136750 Redacted
Tree Asset Owner Approval – Application Form

Tree Asset Owner Approval – Application Form

Tree Protection Plan
Excavation at Beachside Holiday Park,
Mount Maunganui, Tauranga
31st October 2023

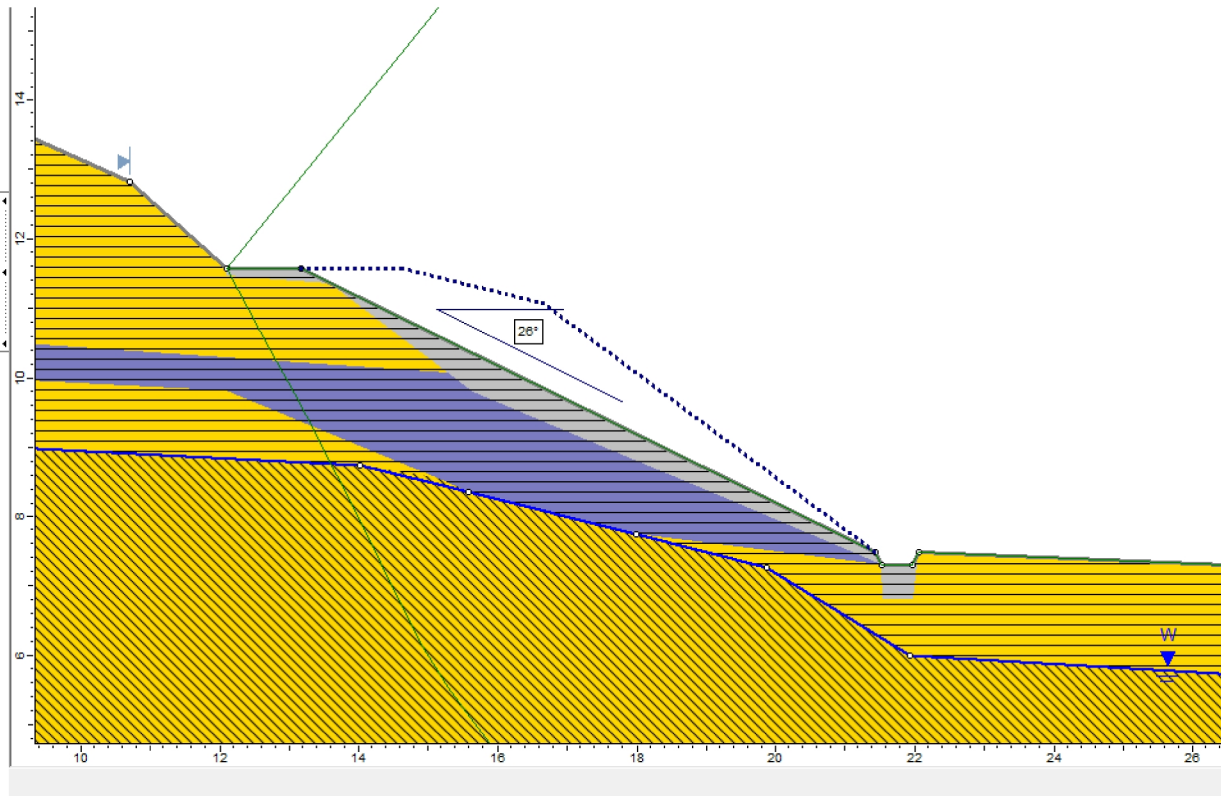
- Our investigation identified a wedge of fill, placed along the outside of the track and possibly to widen the track historically.
- The fill is of variable quality, was wet and has been formed quite steep.

- Our investigation suggests the fill has slumped because of the above, with the recent and heavy rainfall being the main contributor to driving the instability.

- Numerical modelling and analyses suggest they can remove the skip, but they should keep as close to the inside of the track as possible with their truck so they aren't driving directly over the land that has slumped. This should only be done following a period of fine weather and not if there has been recent poor weather.

- Long-term, to allow a habitable structure below the slope, the fill should be regraded to not be steeper than 1:2 (vertical to horizontal) or 26 degrees. See screenshot below, cutting from the dotted profile to the profile shown. By achieving this new profile, the requisite factors for prevailing, elevated groundwater and seismic scenarios are achieved.

- The newly formed cut would need to be topsoiled and/or hydroseeded, and a cutoff drain installed above to help shed water away from the slope.
- This would mean decommissioning of the track, though it would appear the track is only used for access to the skip anyway.

- The cut is also expected to only intercept the fill and not the underlying native ground. However, we don't know if the fill itself is sourced from the Mount (or elsewhere) so cultural standover may be required in any instance.
- Other options could include retaining walls (timber post, or concrete block) however these would take up room within the campsite below and would require building consent. Happy to explore these options, however we feel removing the fill is the ideal solution.
